## **Transport for NSW**

# SSD-9409987, MOSS VALE PLASTICS RECYCLING FACILITY, ENVIRONMENTAL IMPACT STUDY (EIS) – PUBLIC AGENCY CONSULTATION

TfNSW has completed a review of the information provided, including the Traffic and Transport Assessment (report with Project No. 12524108, Moss Vale Plastics Recycling and Reprocessing Facility - Technical Report 6 – Traffic and Transport, Revision 2 dated 27 January 2022 prepared by GHD) while focusing on the impact to the state road network.

## **Attachment 1**

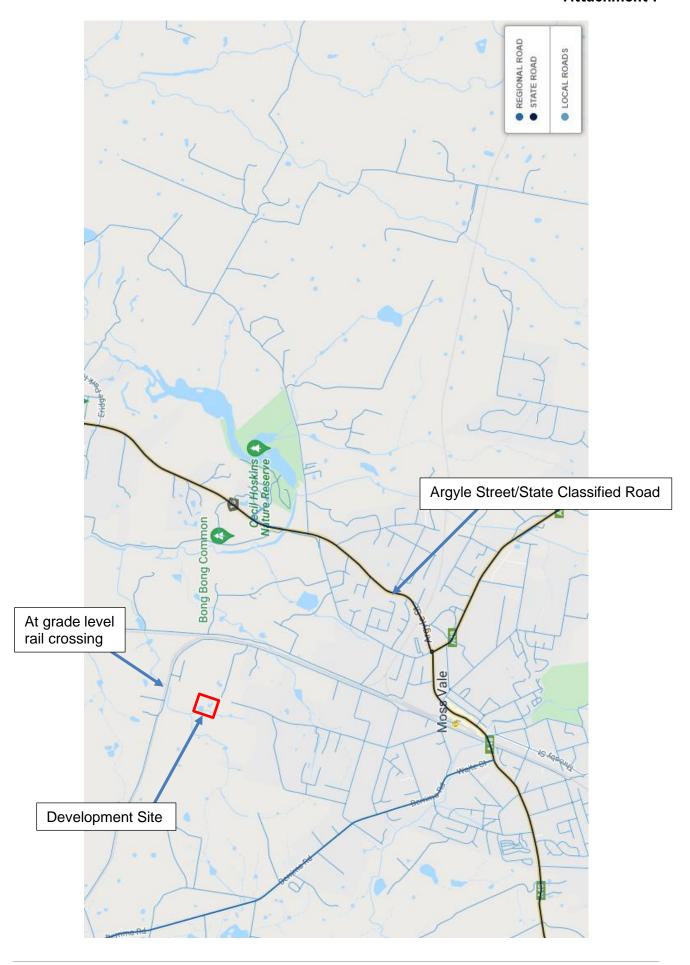
- The key state road is Argyle Street (refer to **Attachment 1**). Berrima Road is a Regional Classified road that is managed by Council;
- The development will generate additional traffic. The impact of this traffic needs to be considered and adequately mitigated; and
- At full capacity (120,00 tonnes per annum) there will be a maximum of 50 trucks per day delivering and exporting plastics. These vehicles access the site from the west along the Hume Highway (Old Hume Highway), Medway Road, Taylors Avenue Douglas Road/ Collins Road and Lackey Road (refer to **Attachment 2**).

TfNSW notes the traffic assessment states that 40% of vehicle movements will be from the north with the proposed haulage route indicating that the trucks that will be delivering and exporting plastics will come from the west (refer to Attachment 2). As such, the proposal will increase the number of vehicles that cross the at grade rail crossing that is located to the north of the development site (refer to Attachment 1).

TfNSW understands that this rail line is a Boral Branch line and is not controlled/managed by the Australian Rail Track Corporation (ARTC). It is however noted that there is limited infrastructure currently provided at this at grade crossing and given the increase in vehicle movements there may be a need to activate the crossing. In this regard, it is suggested that an Australian Level Crossing Assessment Model (ALCAM) be undertaken to identify potential risks and any required upgrades.
